**MONTGOMERY COUNTY HISTORIC PRESERVATION COMMISSION**  
**STAFF REPORT**

<b>Address:</b>	5602 York Ln., Bethesda	<b>Meeting Date:</b>	1/25/2023
<b>Resource:</b>	Contributing Resource <b>Greenwich Forest Historic District</b>	<b>Report Date:</b>	1/18/2023
<b>Applicant:</b>	Jehat Mehmetoglu (Carina Esubalew, Architect)	<b>Public Notice:</b>	1/11/2023
<b>Review:</b>	HAWP	<b>Tax Credit:</b>	partial
<b>Case No.:</b>	1014434	<b>Staff:</b>	Dan Bruechert
<b>Proposal:</b>	Partial Demolition and New Addition, Fenestration Alterations, and Garage Door Replacement.

**STAFF RECOMMENDATION**

SHEET NUMBER:  
**A-04**

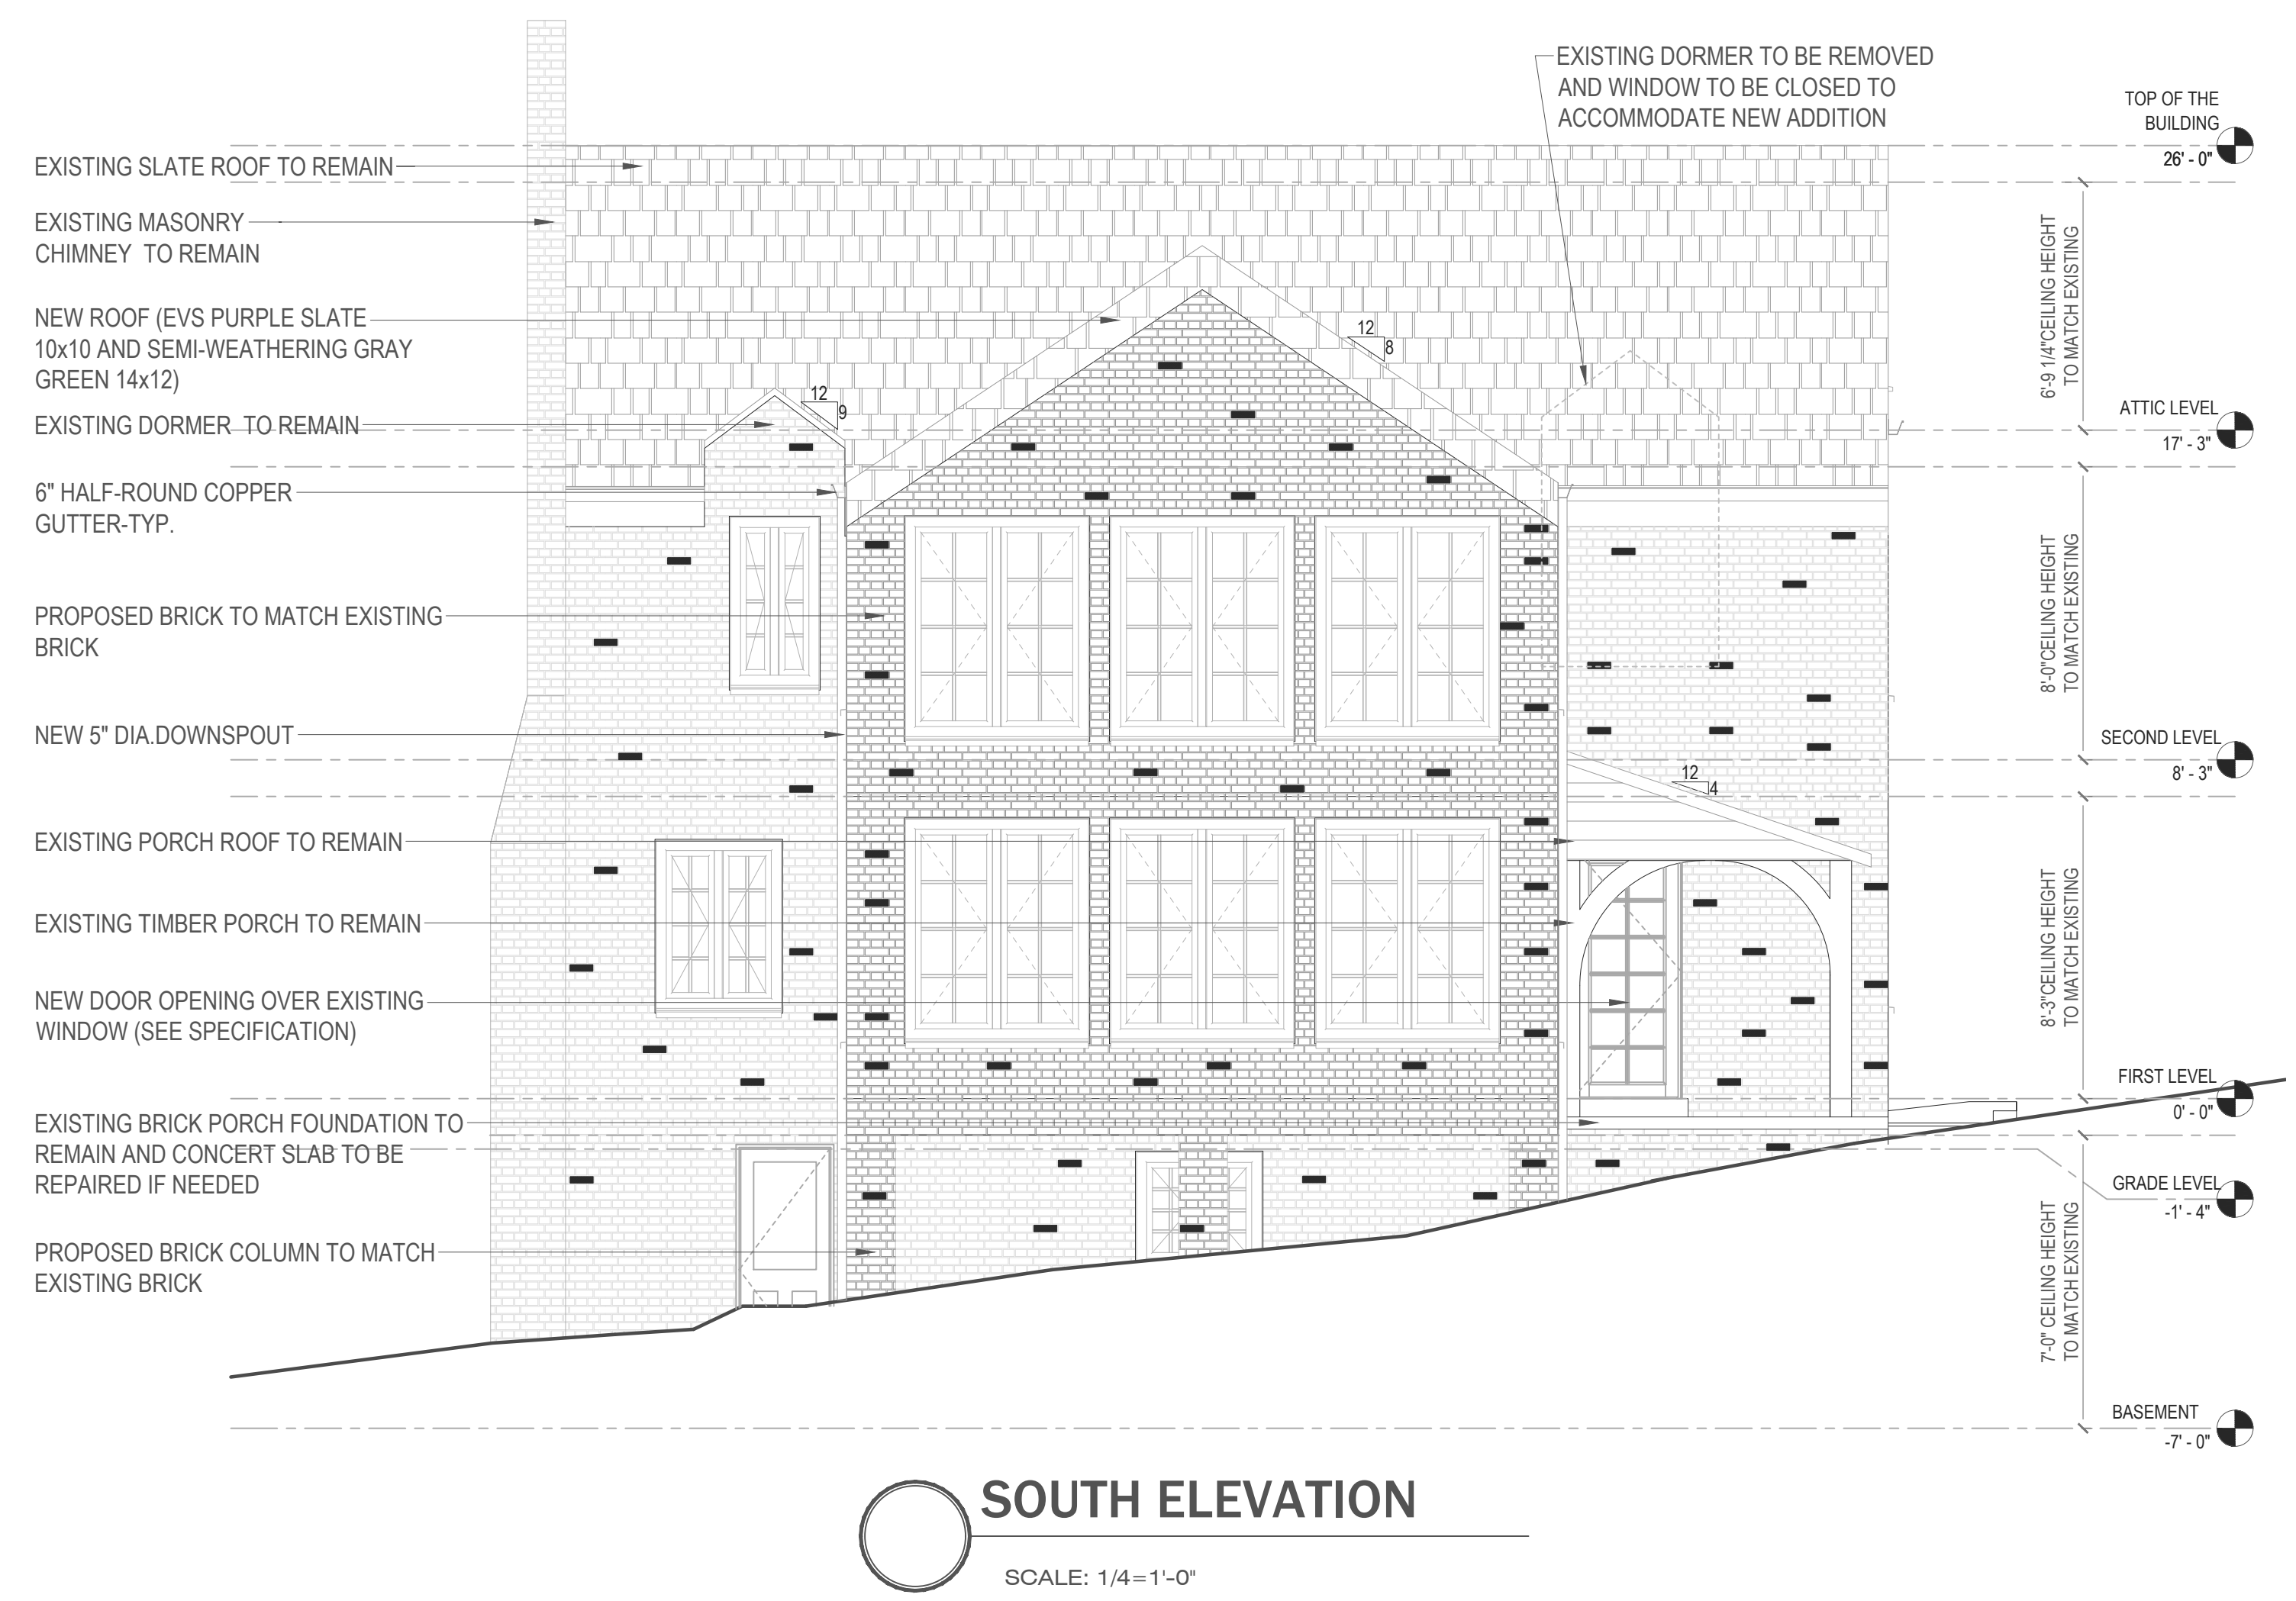
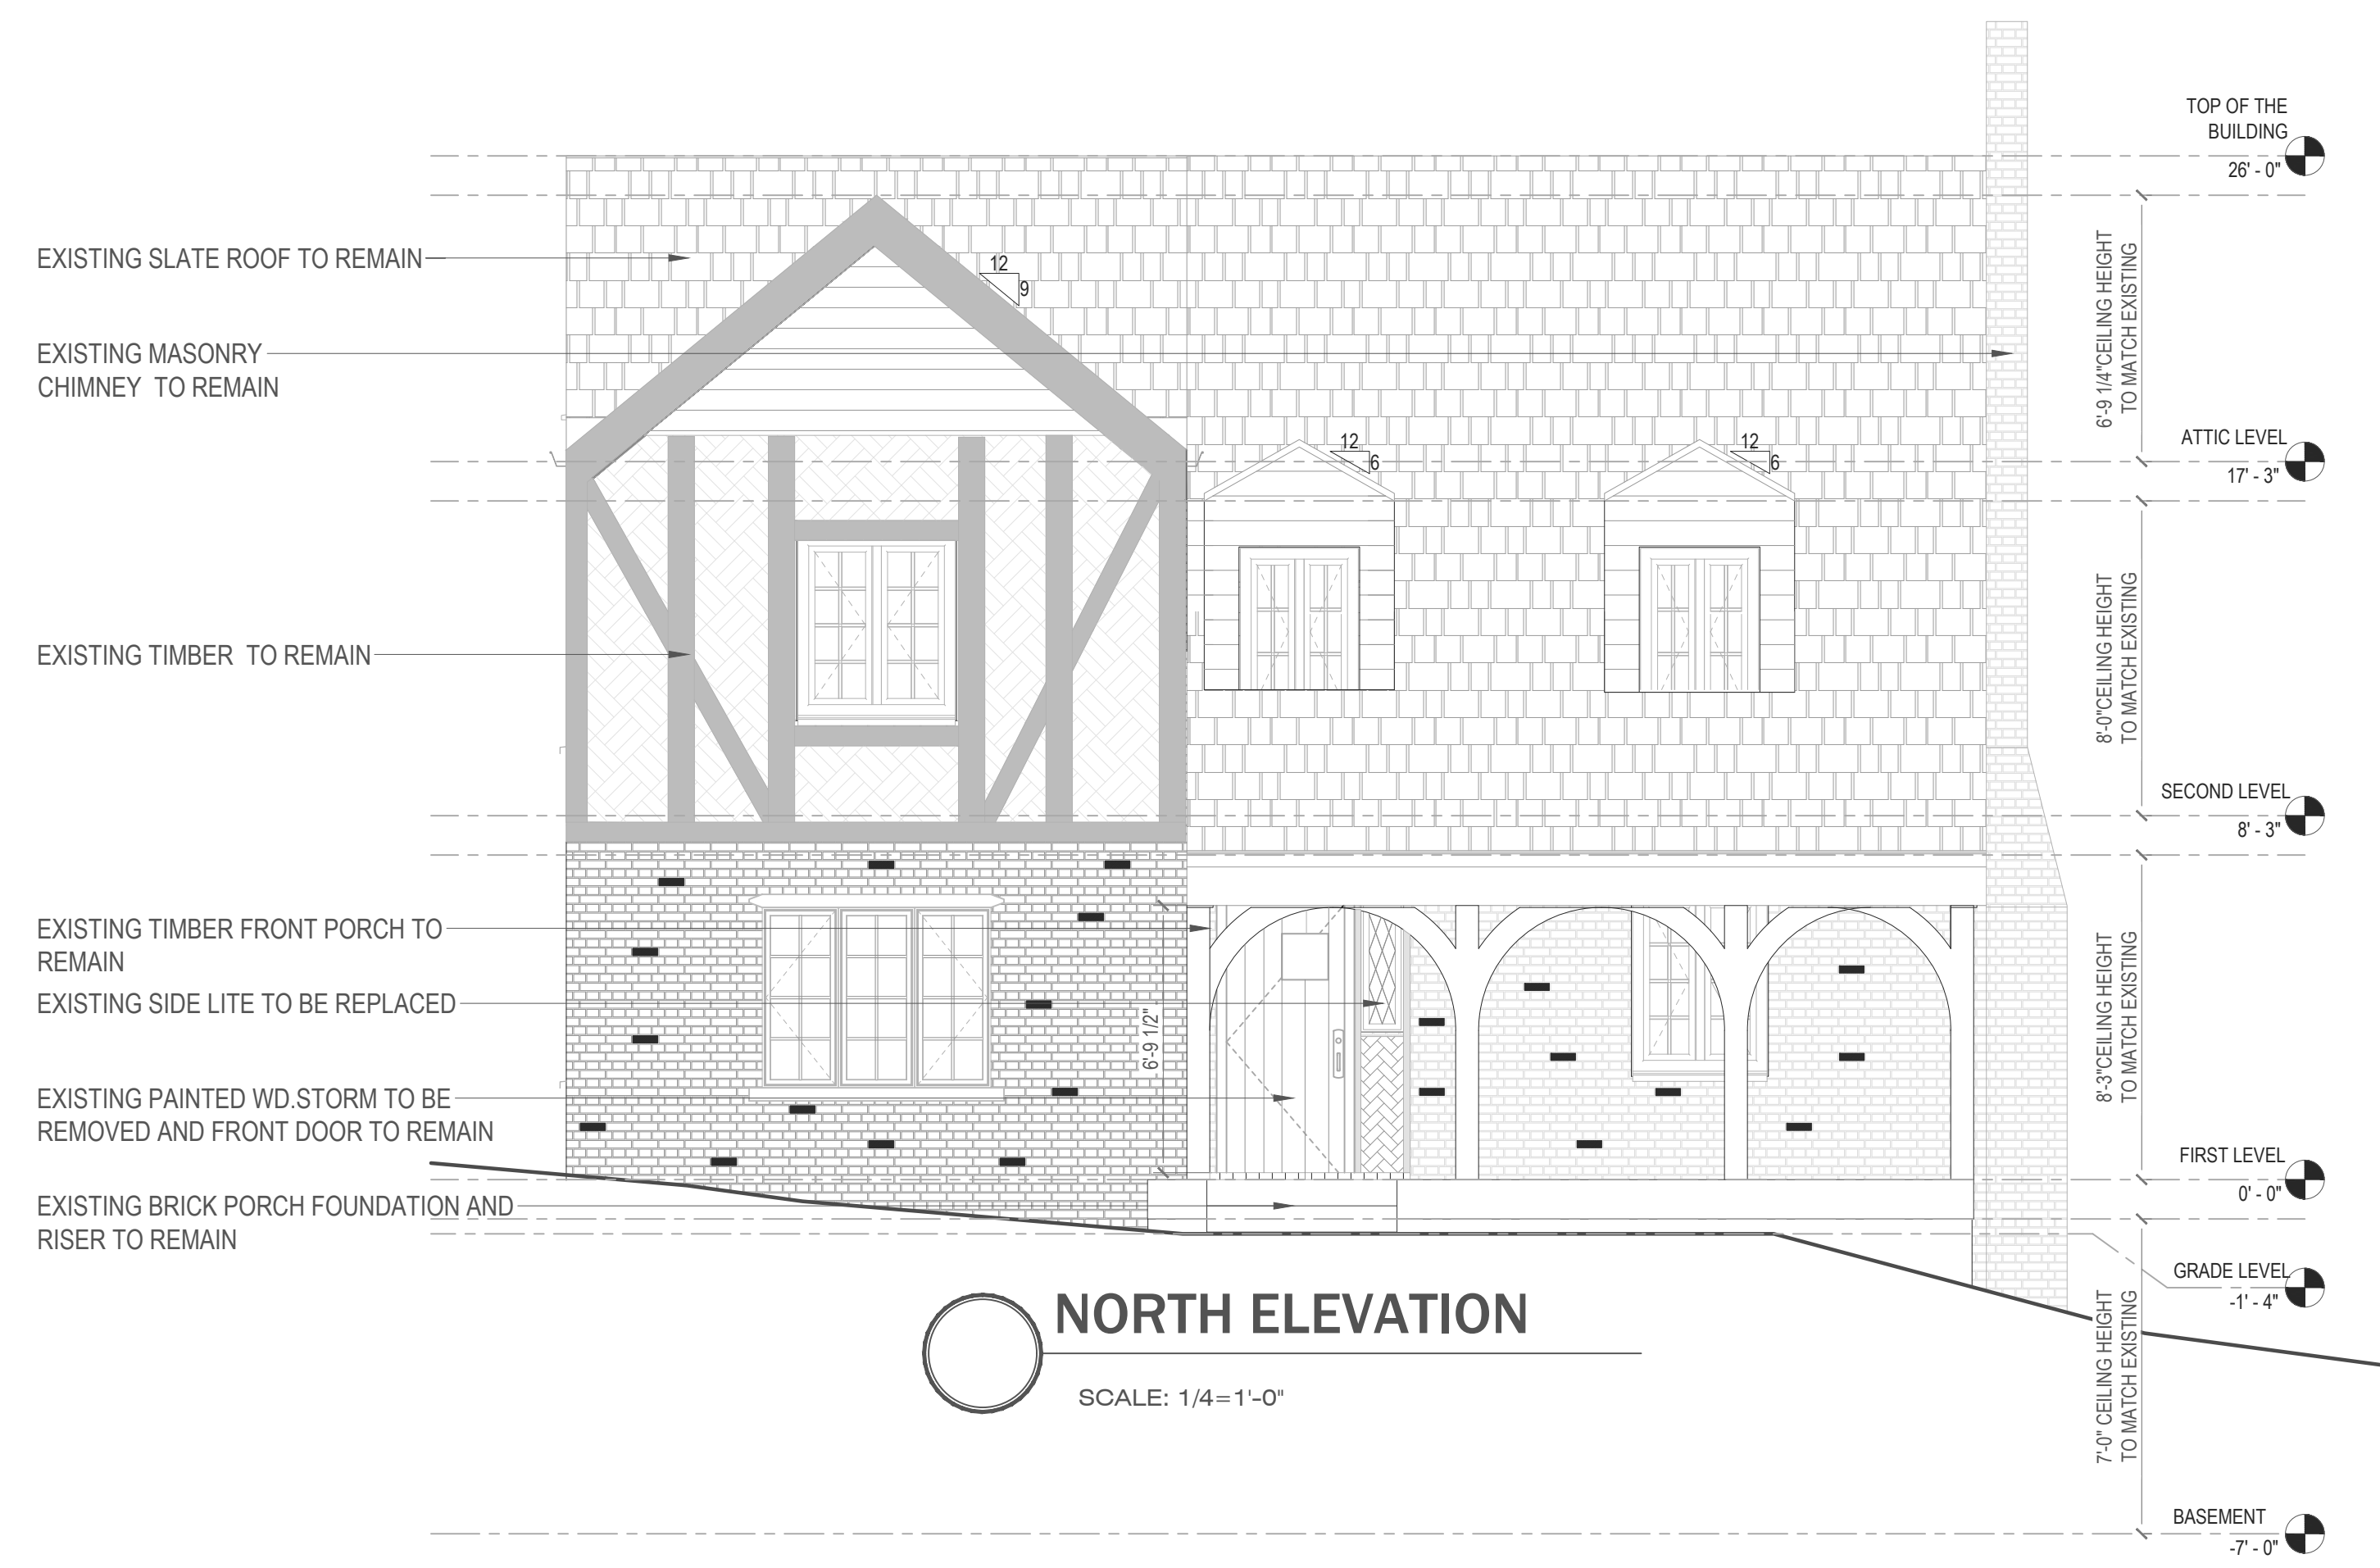
The applicant proposes to remove the existing multi-lite steel casement windows and replace them with new aluminum clad multi-lite windows. Additionally, the applicant proposes to block in two openings: a door on the left elevation towards the rear and a right-side second-story window behind the existing chimney.

The *Design Guidelines* (D17) allow for the replacement of historic windows with new windows that are appropriate for the style of the house without the typical requirement that the windows have deteriorated beyond repair. The applicant provided two window analyses that show the existing steel windows have been altered to accommodate air conditioners, have warped and corroded to the point where an overwhelming majority are no longer functional; the evidence demonstrates the windows have deteriorated beyond repair. At the Preliminary Consultation, the HPC found the proposed multi-lite casement windows to be consistent with the Tudor Revival style of the house.

Staff finds that this change is not an exact, in-kind replacement, but is a de minimis change and recommends the HPC approve it as being consistent with the character of the house and surrounding district under the *Design Guidelines* and 24A-8(b)(1), (2), and (d).

Proposed Brick  
"Blue Bayou  
Clinker"

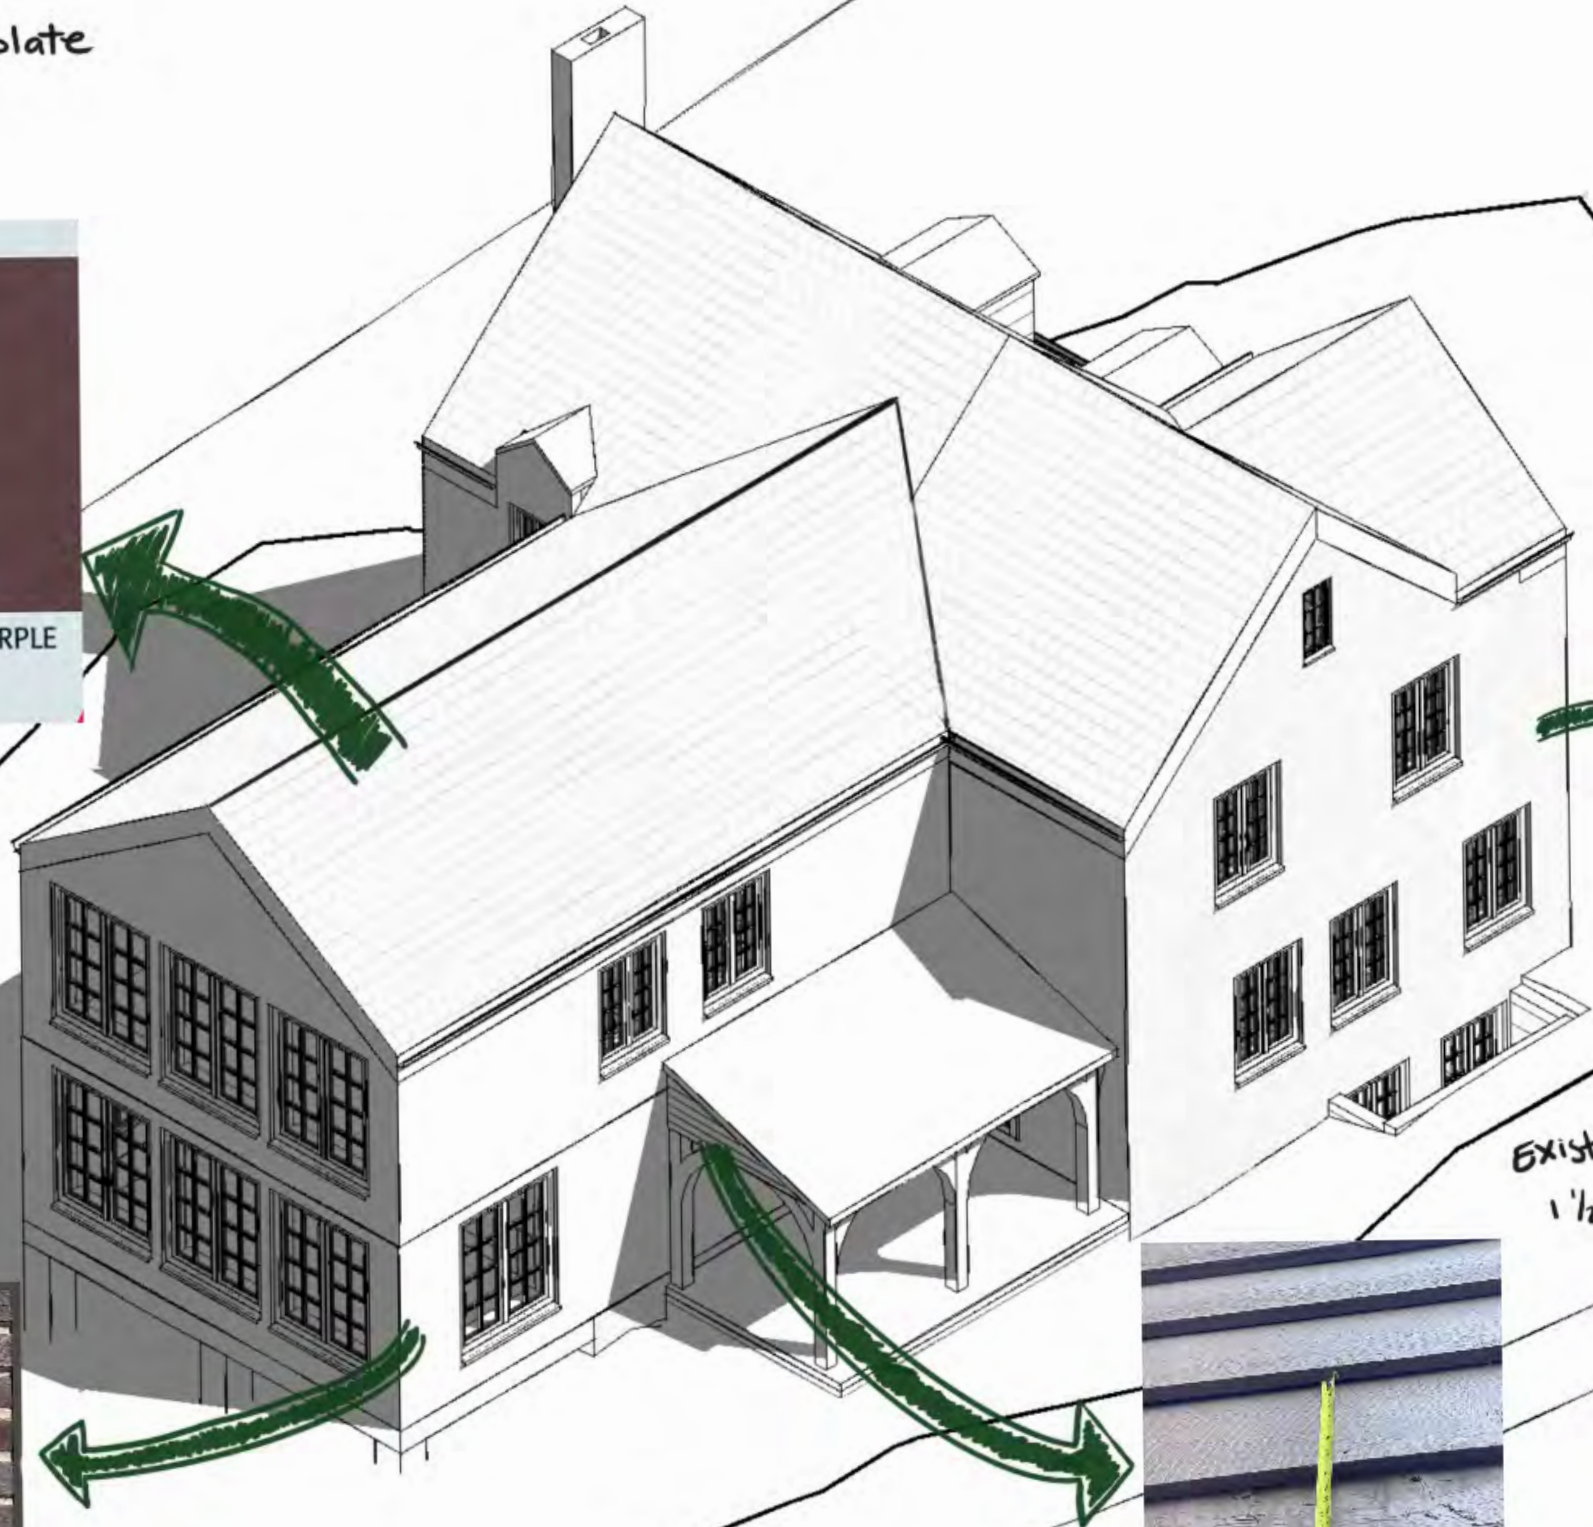
1. The proposed brick and mortar siding will be field verified by Staff to determine a compatible match in color, texture, and striking of the mortar joints. A sample board needs to be provided for review before Staff signs off on the final building permits.
2. The foundation under the rear addition will be continuously finished as masonry faced with brick, not constructed on piers as shown in the drawings. The brick will have all details of a traditionally finished foundation including a water table. Drawings satisfying this condition need to be submitted to Staff for final review and approval.
